The following consultation response was received after the end date of the formal consultation period. This has been italicised and boldened, with officers' responses provided in standard text where relevant. An image of suggestions provided by the consultee is contained on the final page.

Late Response 1:

Suggestion

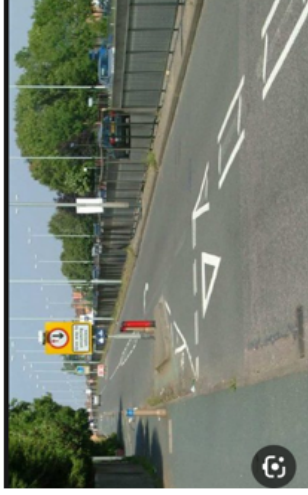
Potential for 'streamlined' bollards/road constriction, with priority for outflowing traffic to deter unwanted use. Provides space for segregated cycle lanes without removing/overlapping pavement outside Summerfields development

Suggest this junction could therefore be made left turn only or left/straight only to ease exit congestion, with the now very limited number of houses affected, no bus stop impacting exit and ability to correct via Avondale and/or Norwood

Two-way access only road, limited to 15mph, with cycle lane priorities

Retain one way approach onto/off the promenade as per consultation approach, but segregated from cycle lane, splitting impacts

Potential for 'streamlined' bollards/road constriction with priority for outflowing traffic to deter unwanted use. Provides space for cycle lanes to integrate with main road flow via stepped system (cycle priority – one way – dual traffic)

It is unclear how the suggestions in the above text and below image would provide solutions to the scheme's objectives whilst complying with guidance document 'LTN 1/20' and any regulatory requirements including the 'Traffic Signs Regulations and General Directions 2016'.

For example, there is no permitted mechanism to maintain a two-way entry / exit from a side road junction whilst giving priority to outgoing traffic over incoming traffic. To do so further inset from the junction within the constraints would not provide adequate stacking space for vehicles and may not discourage vehicles from entering. To build out the junction to a one-way width whilst maintaining two-way traffic is likely to cause safety issues. The one-way restriction is proposed to facilitate a safe pedestrian / cycle crossing whilst allowing cyclists to safely transition back to the carriageway on Todmorden Road. The two-way suggestion below does not remove the safety issues from increased traffic flows entering from Clifton Drive North and could increase safety issues by giving entering drivers an extra element of traffic to give way to.

15mph speed limits as shown below on a length of North Promenade are not permitted within the regulations. The access only proposal over the same length would increase vehicles turning in to Bentinck Road unnecessarily, where vehicle movements in the

opposite direction on Bentinck Road are likely to increase under both the current proposal and that suggested below. The current proposal mitigates that by prohibiting motor traffic entering Bentinck Road from North Promenade, whereas the below would exacerbate this.

The length of one-way proposal northbound means drivers entering Bentinck Road from Clifton Drive North would have no clear through route when reaching the junction with North Promenade due to the length of access only further north and would have inadequate space to turn around.

In summary, many of the benefits listed by the consultee fall outside of the projects scope, it is unclear if those benefits would be provided by the suggestions highlighted, and some of those suggestions are not permissible within the regulations.
